# UNITED STATES PATENT AND TRADEMARK OFFICE

APPLICATION NO.	FILING DATE	FIRST NAMED INVENTOR	ATTORNEY DOCKET NO.	CONFIRMATION NO.
10/580,272	05/25/2006	Nobuhiro Nakamura	2257-0259PUS1	5982

<b>Office Action Summary</b>	<b>Application No.</b>	<b>Applicant(s)</b>	
	10/580,272	NAKAMURA ET AL.	
	<b>Examiner</b>	<b>Art Unit</b>	
	Shawn Riley	2838

## **DETAILED ACTION**

FIG. 7

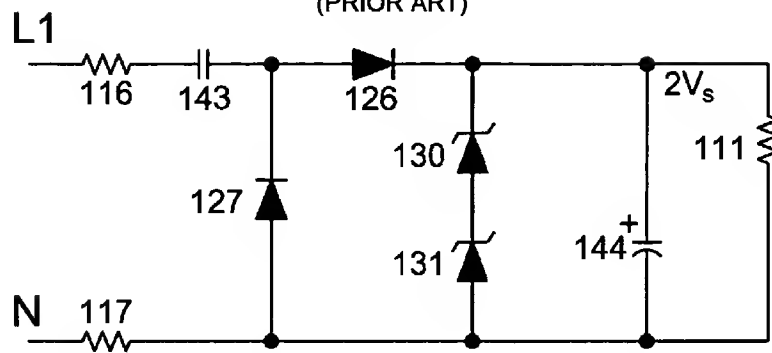
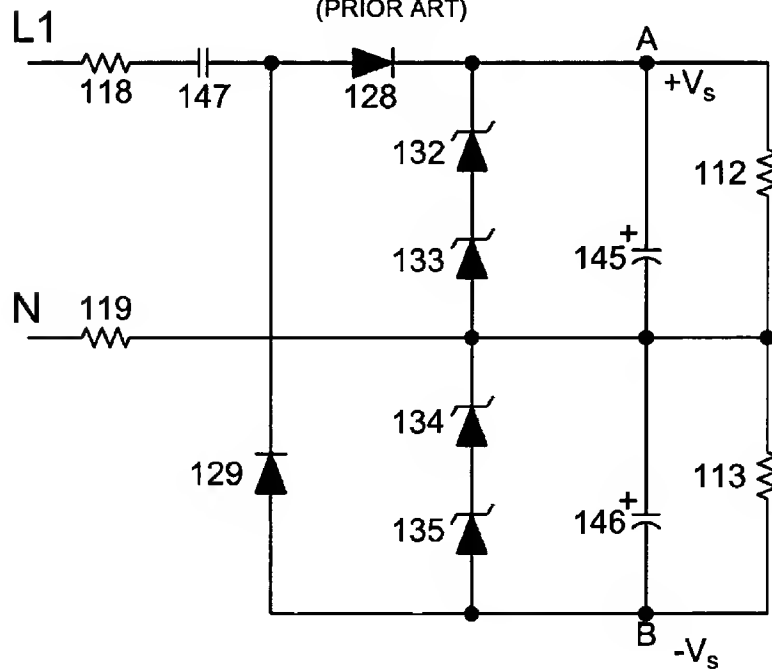
2. Claims 1-3, 5-7, 11, and 13 are rejected under 35 U.S.C. §102(e) as being fully anticipated by Momber (U.S. Patent 7,259,479). Momber shows,<sup>1</sup> (in, e.g., the(ir) figures 7-8 and corresponding disclosure)

A power converter for stepping down and converting AC voltage to DC voltage, said power converter comprising: first and second input connections (L1 & N) for inputting output of said AC voltage; a first capacitor (143) and a second capacitor (144) interposed in series on a first electric connection line between said first input connection and said second input connection, connection in order from a side of said first input connection; a first diode (126) interposed between the first capacitor and said second capacitor on said first electric connection line so that its forward direction is toward said second input connection; a second diode (127) interposed on a second electric connection line so that its reverse direction is toward said second input connection, said second electric connection line connecting a point between said first capacitor and said first diode on said first electric connection line, and said second input connection; a first output connection (at, e.g.,  $2V_s$ ) for output of said DC voltage, which is connected between said first diode and said second capacitor on said first electric connection line; and a second output connection (connection node between 111 and 144) for output of said DC voltage, which is connected to said second input connection.

The power converter as set forth in claim 1, further comprising: a Zener diode (130/131) interposed between said first output connection and said second output connection so that its forward direction is toward said first output connection.

The power converter as set forth in claim 2, further comprising: a resistor (TH) interposed on said first electric connection line on a side closer to said first input connection than a position of connection with said second electric connection line (this line connection could be any second connection input/output apparently).

The power converter as set forth in claim 3, further comprising: a third capacitor (figure 8-146) connected between one end of said resistor (118) and said second input connection (N),

The power converter as set forth in claim 5, wherein said one end of said resistor (118) is the end on the side of said second input connection.

The power converter as set forth in claim 1, further comprising: a resistor (116) interposed on said first electric connection line on a side closer to said first input connection than a position of connection with said second electric connection line.

4. Claims 4, 8-10, 12 and 14-19 are rejected under 35 U.S.C. § 103 as being unpatentable over Momber (U.S. Patent 7,259,479). The Momber reference discloses the limitations of the invention as claimed as described above. However, Momber does not

show the resistance as a thermistor or the ratio of the capacitances to each other. It would have been obvious at the time the invention was made to utilize thermistor or the ratio of the capacitances to each other into the circuit of Momber for the reason of a design choice, wherein, e.g., the use of a thermistor could provide protection by reducing current overload by the well know protection mechanism of increasing the resistance of the element/resistance as the device heated up do to increased current, and likewise the setting of different ratio's of the capacitance is within the skill of a designer for such reasons as providing a storage means for excess voltage/power or even a filtering means.
